# Excavation Scope Final Design

Arup Final Design Kick-Off Meeting

November 7, 2017

# Changes from what you've seen in the PDR

## Changes to EXC scope – Cavern Design – Chamber 1 & 2 Bulkhead & Mid-Cavern Access Drift

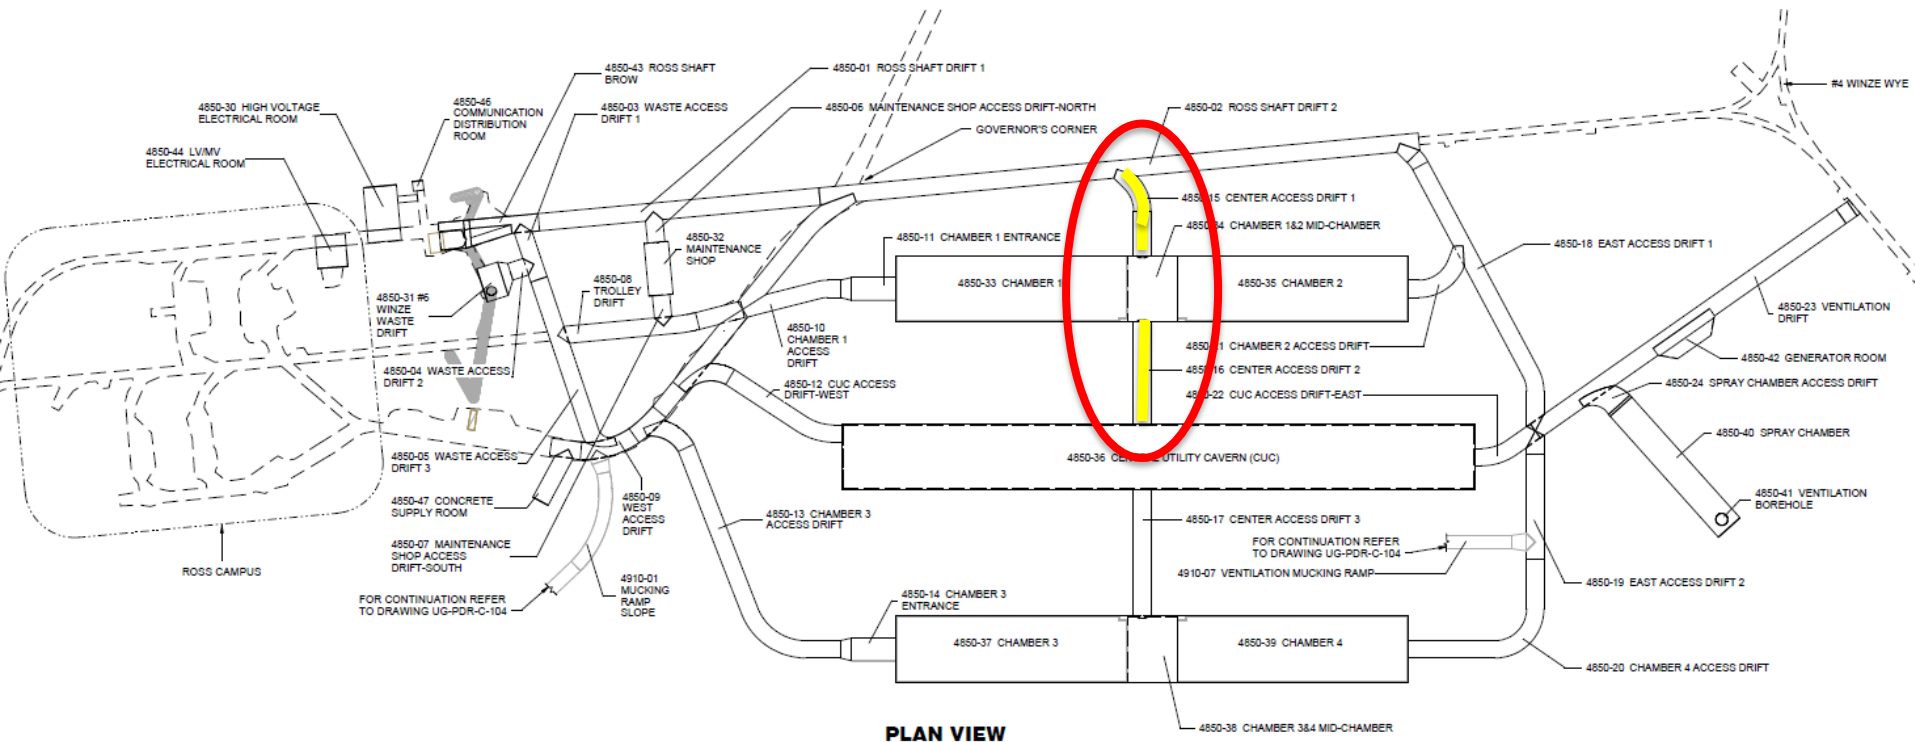
- The Preliminary Design includes a bulkhead between Chambers 1 and 2 to allow construction of a cryostat structure with concurrent excavation of chamber 2. This bulkhead required the access drift to be designed with an offset from the center alignment with the septum pillar.
- The Final Design shall remove the bulkhead design from the scope of work and include a shift of the center line for the mid-cavern access drift to the center of the septum pillar.

# DUNE DocDB 464 - Control Drawing F10043159

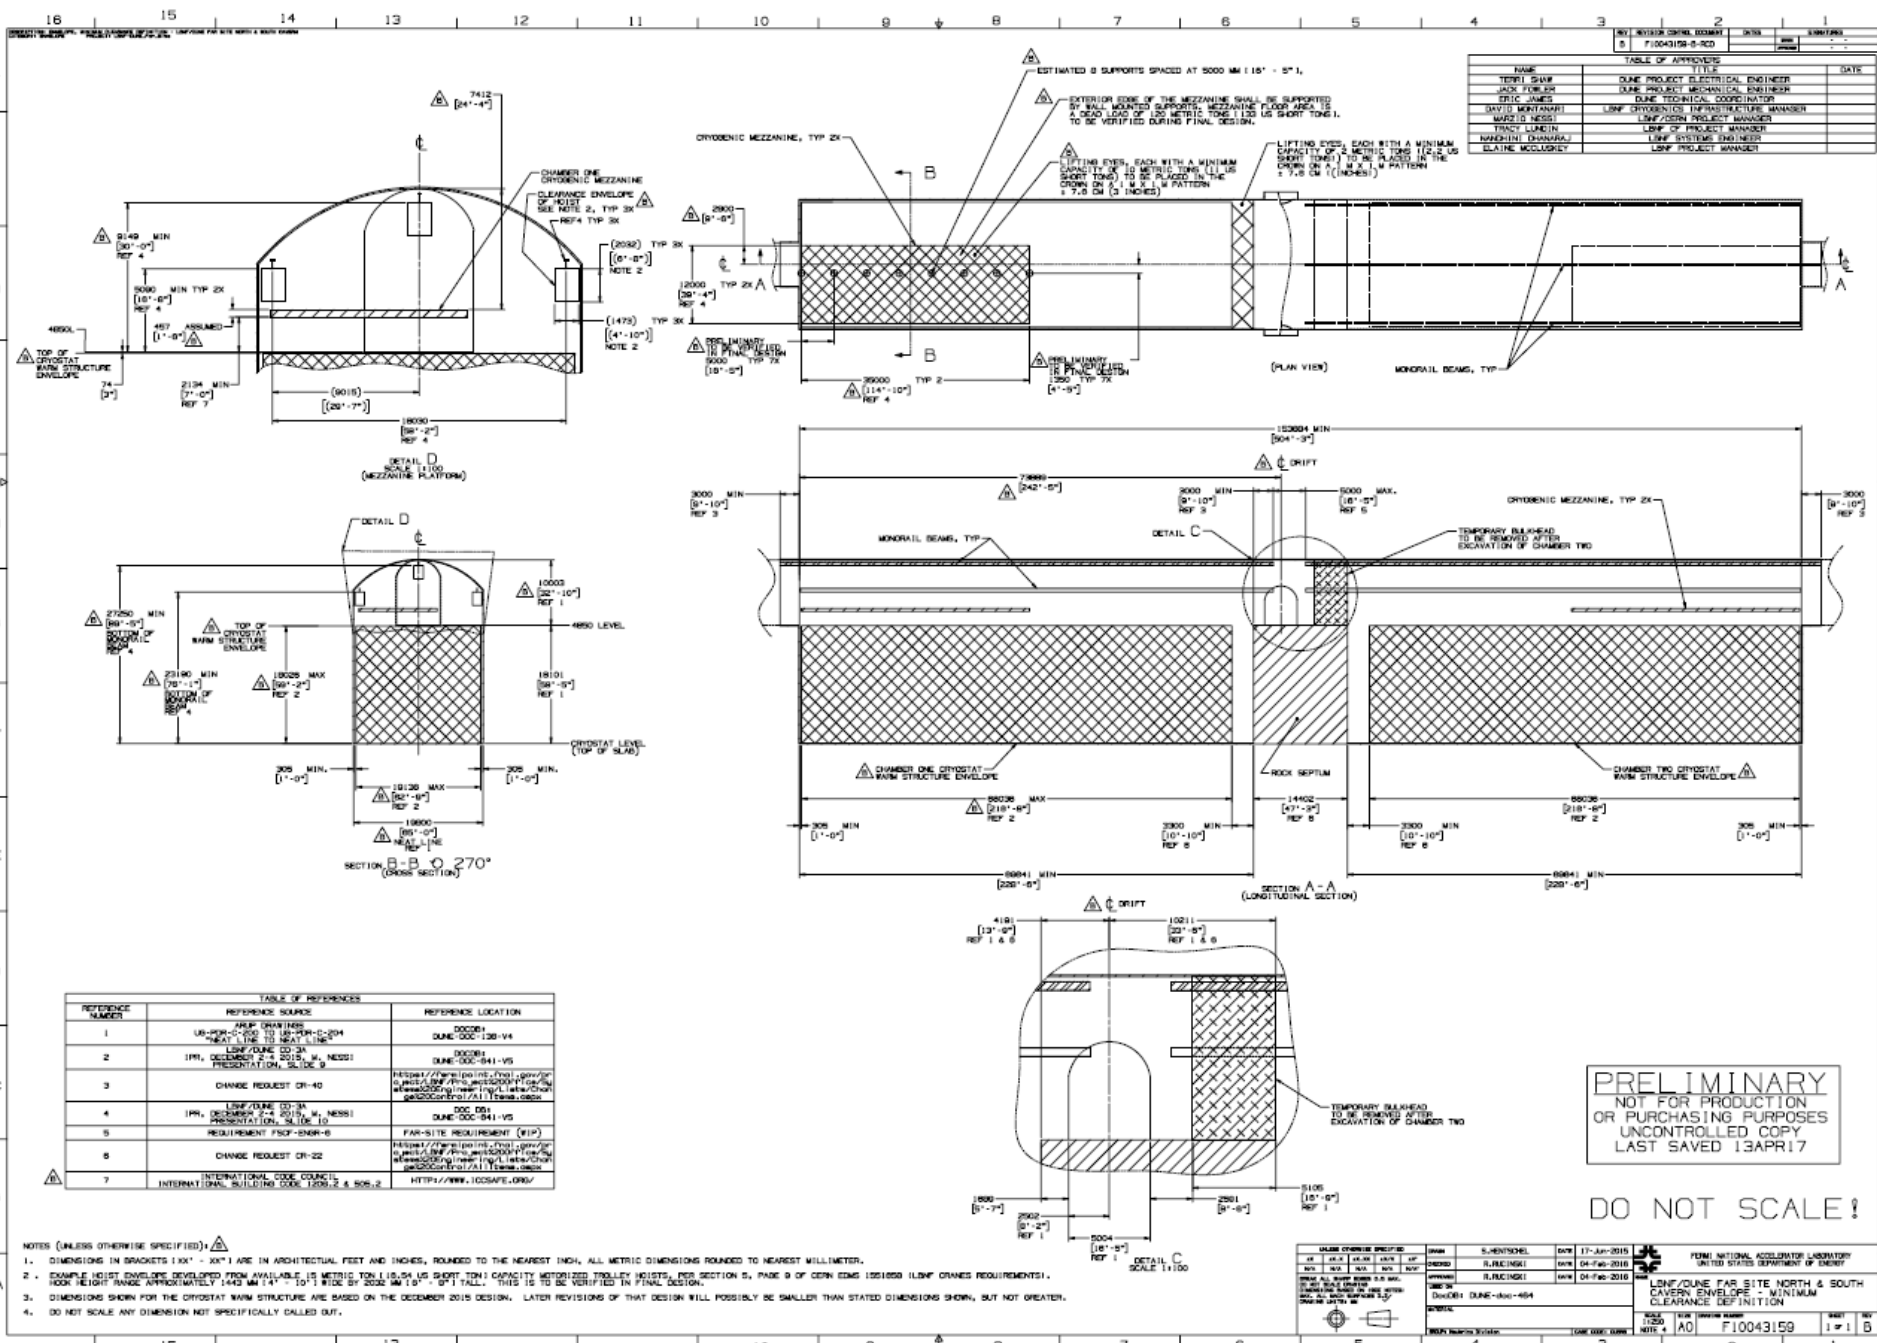
- The Final EXC Design shall include a reduction in septum pillar width to 14.4m, increasing each chamber's overall length by 0.3m. The overall Cavern length does not change.
- See DUNE DocDB 464 - Control Drawing F10043159

- The Final EXC Design shall include addition of drift-width (minimum), 3m deep, “antechambers” to both ends of the detector caverns, extend monorail into that space, and move the AHU’s accordingly.
- See DUNE DocDB 464 - Control Drawing F10043159

- The Final EXC Design shall include addition of connections/supports and wall mounted supports design for 10m x 35m mezzanines on the CUC side of each detector chamber.
- The Pending Change of a shift in location of the mezzanine by 3m may potentially add 1 or 2 additional support points. Please see David Montanari's presentation slides # 6 thru #10.
- The Final EXC Design shall include a pattern of ten – 100 metric ton capacity lifting eyes above each mezzanine, and two – 100 metric ton capacity lifting eyes above each cryostat bridge, for material lifting at each location.
- Each anchorage (lifting eye) to be designed and installed to provide 100 metric ton capacity.
- Please see David Montanari's presentation slide # 19 for details on attachments.
- See DUNE DocDB 464 - Control Drawing F10043159

- The Final EXC Design shall include 15 – metric ton minimum capacity monorails and hoists.
- The Final EXC Design shall include two sets of three 15 – metric ton capacity monorail hoists (chamber 1 & 2).
- The Final EXC Design shall verify hook height/width clearance envelope and monorail beam locations shown on Control Drawing F10043159.
- The Final EXC Design shall verify all other clearance envelope dimensions shown on Control Drawing F10043159.
- The Pending Change to accommodate a bridge crane will be in addition to the monorails stated above.
- See DUNE DocDB 464 - Control Drawing F10043159

# Chamber 1-2 Bulkhead Removal

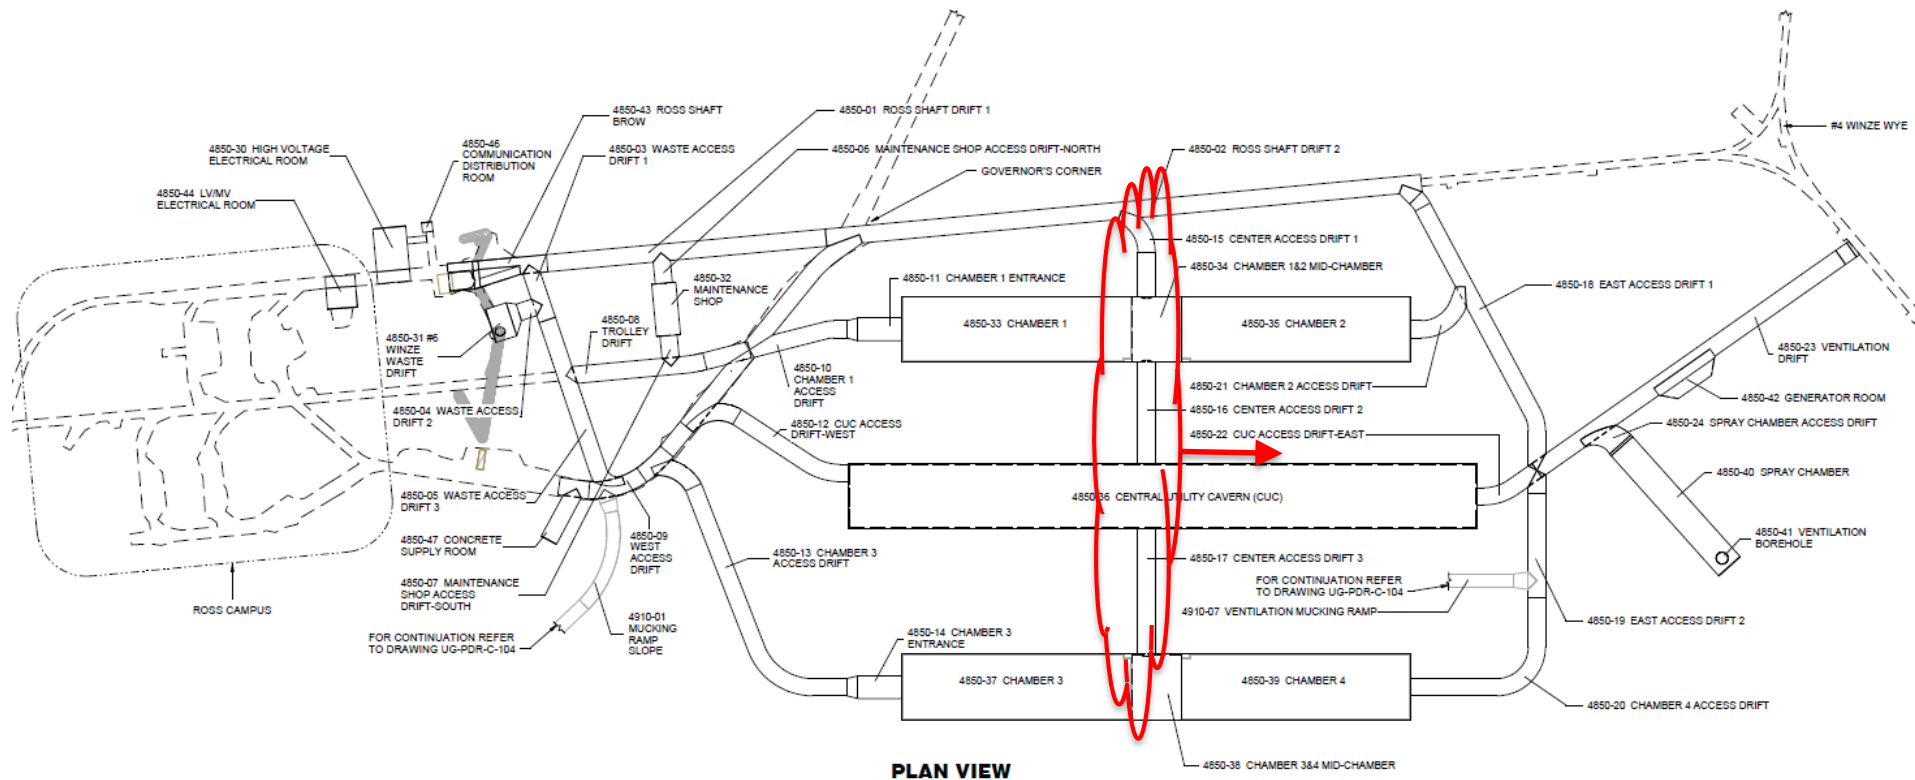
The Preliminary Design planned to incorporate a bulkhead between Chambers 1 and 2 to allow construction of the cryostat warm structure to begin while excavation of chamber 2 completed. This bulkhead required the access drifts to be offset from center. A change is proposed to eliminate this bulkhead and shift the drifts to center.

## Rock Spill Collection System Change #2

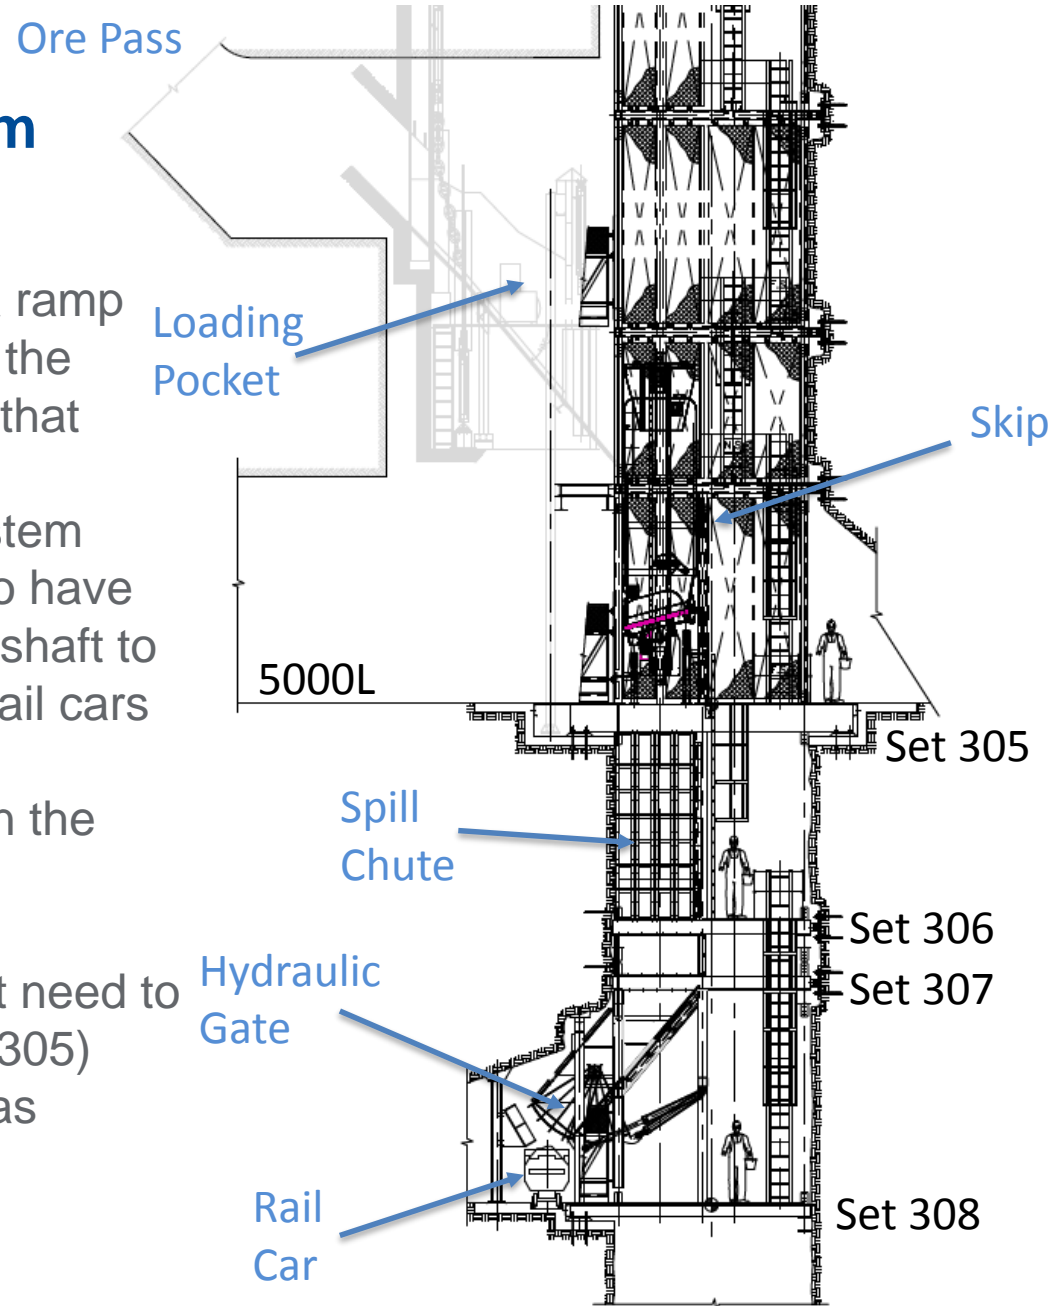
- The preliminary design included a ramp from the bottom of the detector to the bottom of the shaft to collect rock that spills while loading skips.
- We realized that we needed a system much earlier than this provided, so have designed a system internal to the shaft to store spilled rock and load it into rail cars for disposal. This system allows elimination of the ramp, which is in the budget at ~\$3.6M
- Without this system (and LBNF excavation), the SDSTA would not need to rehabilitate below the 5000L (Set 305)
- GL Tiley has estimated this work as described on the following slide.
